## 概要

この通知は、ザイリンクス VOG48 TSOP パッケージ用に新しい出荷トレイが追加されることをお知らせするものです。

表 1: トレイ情報

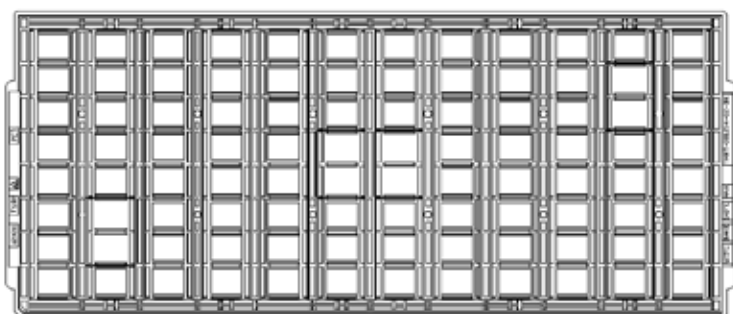
Daewon 社が製造する出荷トレイがザイリンクス VOG48 パッケージ用として追加されます。

新しい Daewon 社製のトレイのマトリクスは、PCT Technology 社製のトレイと互換性があり、X/Y 寸が一致します。ただし、Daewon 社製のトレイには滑り止めが付いているため、これら 2 社のトレイを積み重ねることはできません。これら 2 社のトレイを重ねたり、混ぜて使用したりしないことを推奨します。

ザイリンクスは 2011 年 5 月 1 日より、新しいトレイの使用を開始します。
